Subject: 3055 Richmond Holding Inc. – 3055 Richmond Road – Site Plan Control Application 7th Submission - City File No. D07-12-22-0147

On behalf of 3055 Richmond Holding Inc. (the “Client”), please find enclosed, the seventh submission for the Site Plan Control (File No. D07-12-22-0147) Application, located at 3055 Richmond Road, in the City of Ottawa. The enclosed resubmission package addresses the City’s comments received on October 30, 2025.

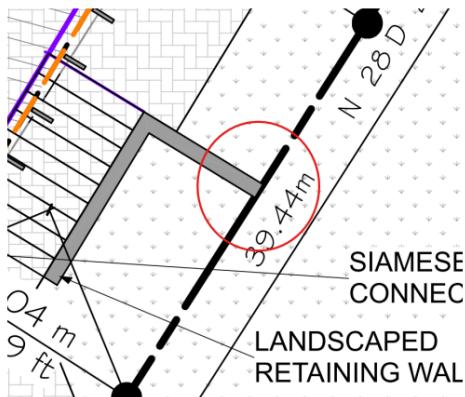
1. **Please label the rear yard landscaping/amenity area, and provide the dimensions.**

- a. **Further, please clarify on the site plan how the rear yard amenity area is accessed, and indicate any provided pathways.**

City Response: Acknowledged. If rear yard area is included in amenity area calculation, please add a note identifying it as an “amenity area”.

The Site plan has been modified to clarify amenity area vs rear yard soft landscaping. Rear yard soft landscaping is 167.9 m², and amenity area is 180.6 m².

Communal:

125.7 m² - Rooftop balcony

32.9 m² - 4th floor balcony

180.6 m² - Rear yard area

Total: 339.2 m²

Private:

30.6 m² - Large 4th floor balcony

15.0 m² - 5 smaller private balconies

Total: 45.6 m²

Total area: 384.8 m²

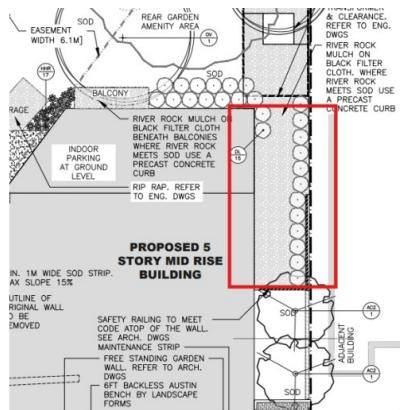
6. **Please review rooftop area, currently labelled as “public balcony”. If no public access is intended, it should be relabelled as above.**

This was always intended as a public space, no changes made.

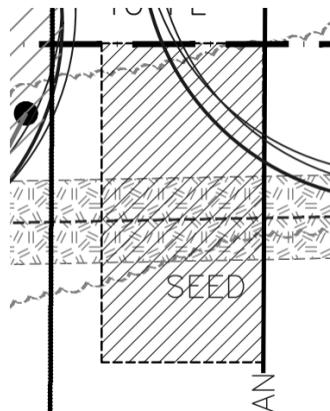
8. **Is there an opportunity to replace some of the river rock along the east side of the property, between the proposed trees and transformer, with additional trees or other plantings?**

Tight space limitations, the neighbour's retaining wall and minimal light make it difficult for any small tree to grow other than Nannyberry which is a large shrub. It does well in shade and we have added three to the plan.
